**Southern California Edison Calculation M-DSC-356,
"Evaluation of Modified Pressurizer Heater Sleeves"**

| Southern California Edison Company INTERIM CALCULATION CHANGE NOTICE (ICCN) CALCULATION CHANGE NOTICE (CCN) COVER PAGE SUMMARY CHANGE <input checked="" type="checkbox"/> NO <input type="checkbox"/> YES | CALC NO. M-DSC-356 | | ICCN NO./ N-3 PRELIM. CCN NO. | PAGE 1 | TOTAL NO. OF PAGES 15 |
| | CALCULATION SUBJECT: Evaluation of Modified Pressurizer Heater Sleeves | | | | |

ATTACHMENT III - Evaluation of Fillet Weld at the Pressurizer Heater Sleeve/Heater Sheath Connection

Figure 8.1 Schematic of the heater sleeve to heater sheath fillet weld connection

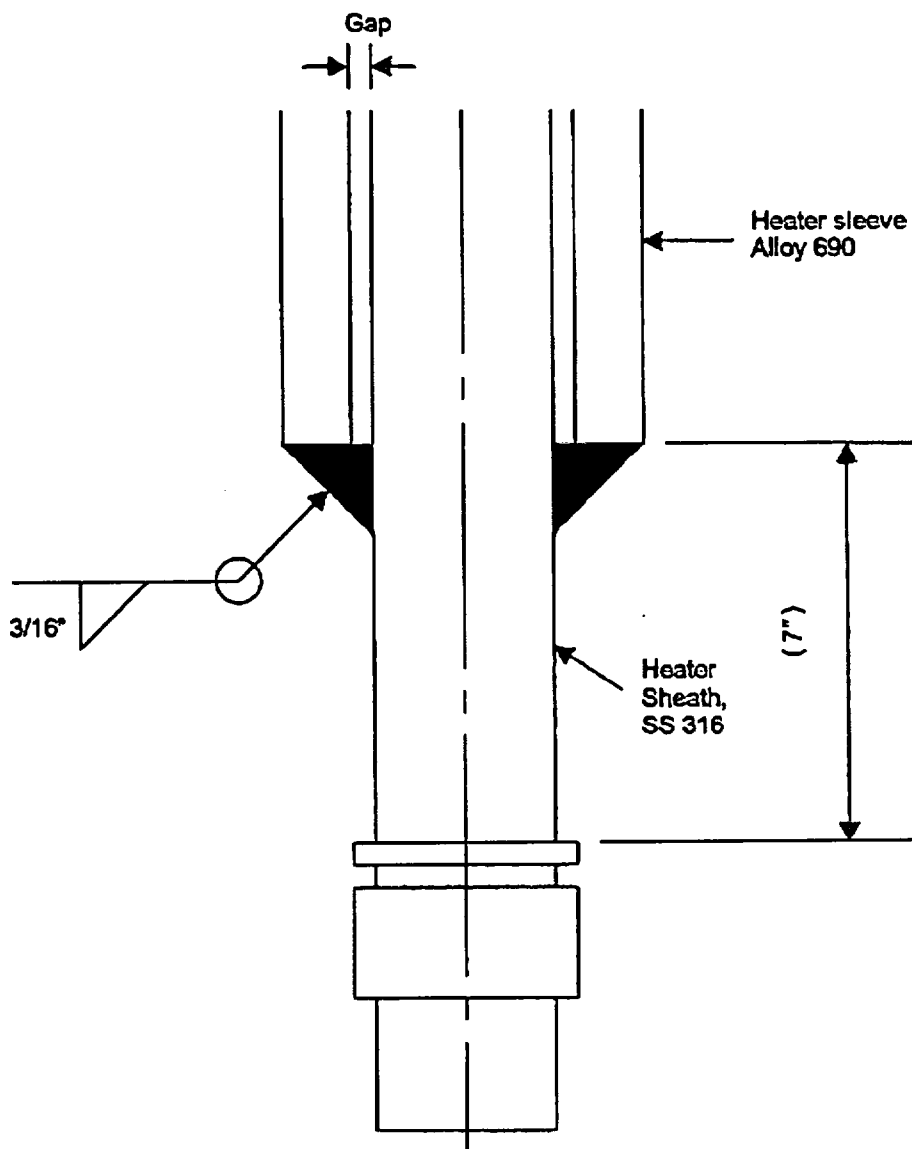
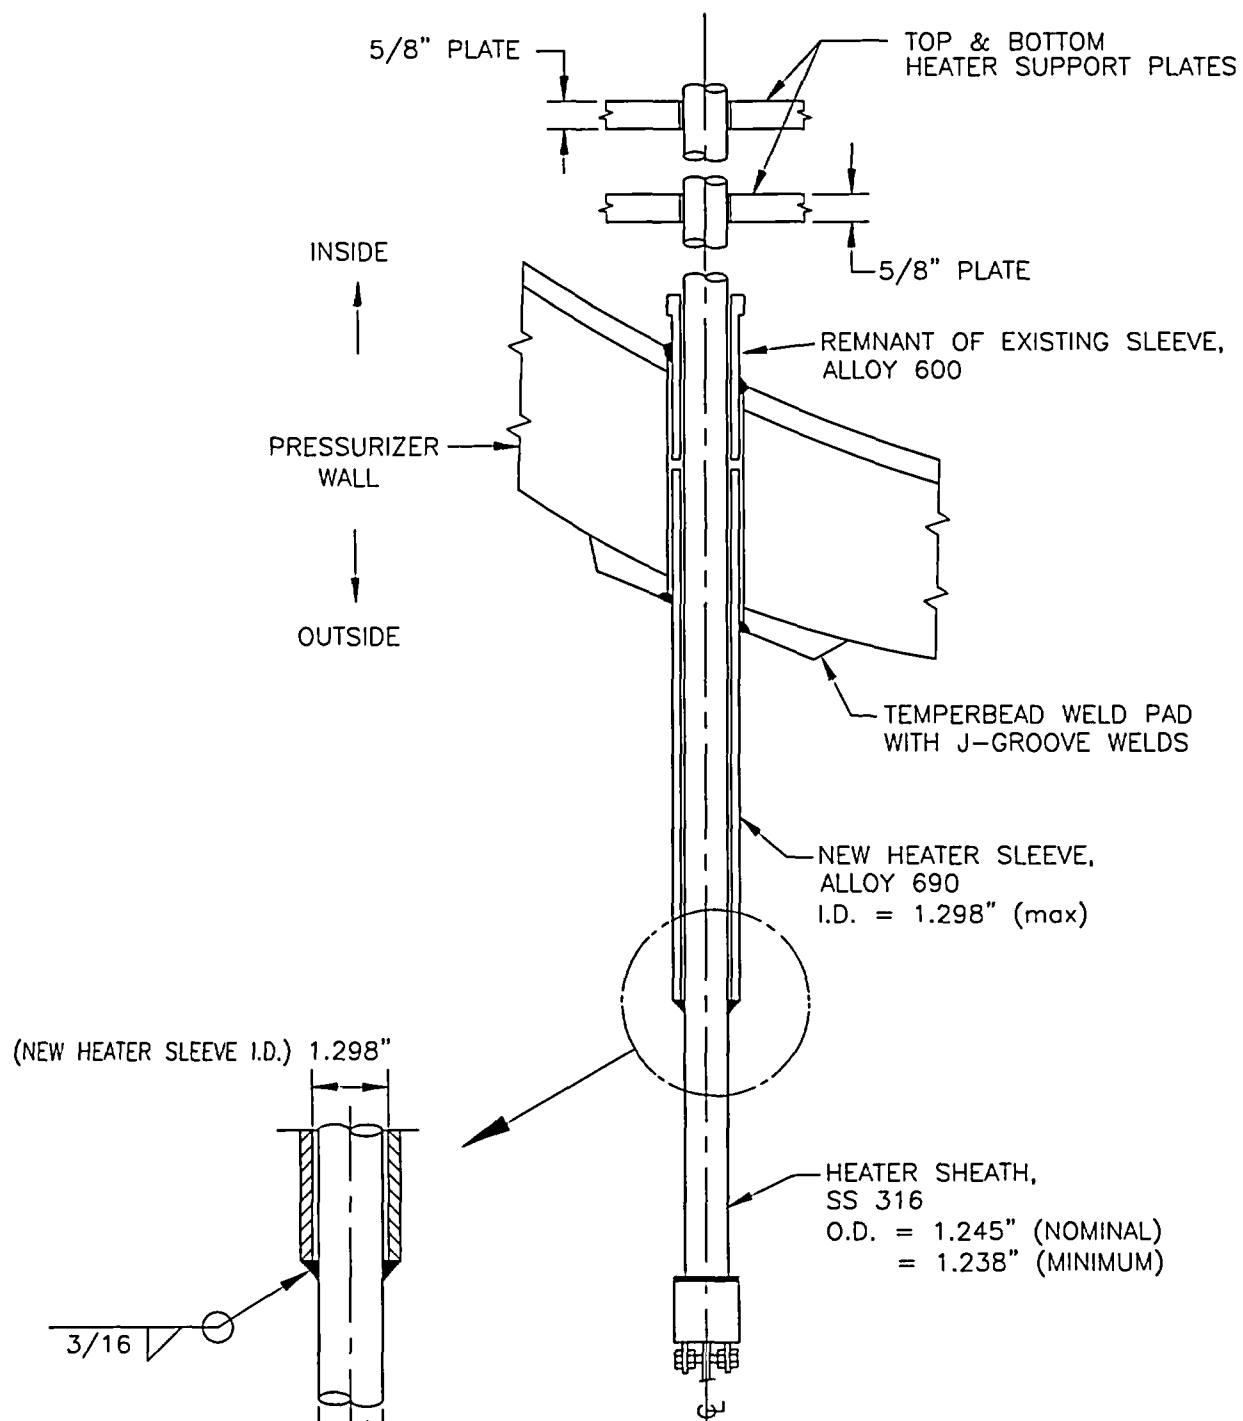
The purpose of this CCN is evaluate the acceptability of the fillet weld connection between the Pressurizer heater sleeve and heater sheath using a maximum diametral gap of 0.060". The maximum gap tolerance of 0.060" is necessary to resolve the insertion difficulty encountered subsequent to the implementation of a half-nozzle repair of the Pressurizer sleeve. The diametral gap tolerance used in the original construction was 0.045" maximum.

The original C-E Analytical Report [6.1] evaluated the sleeve to sheath fillet weld for Primary Membrane (P_m), Primary + Secondary ($P_L + P_b + Q$), Shear (τ) and Fatigue Usage Factor. The new 3/16" fillet weld size has a throat which is reduced from that originally evaluated due to the increase in gap between the heater sleeve and heater sheath. The increase in gap also increases the stress due to the internal pressure.

See Figure 8-1 for the schematic configuration of the heatersleeve to heater sheath fillet weld connection.

The throat of the fillet weld evaluated in the original C-E Analytical Report was 0.1227". For the new configuration, the weld throat is calculated as follows:

throat size = $(0.619 + 0.1875 - 0.649) \times 0.707 = 0.111"$,
where: outside radius of heater sheath = $1.238 / 2 = 0.619"$ (min. radius)
inner radius of heater sleeve = $1.298 / 2 = 0.649"$ (max. radius)
fillet weld size = 0.1875".

NOMINAL DIAMETRAL CLEARANCE
= (1.298" - 1.245") = 0.053"

MAXIMUM DIAMETRAL CLEARANCE
= (1.298" - 1.238") = 0.060" = **cMAX**

cMAX = 0.060" REQUESTED
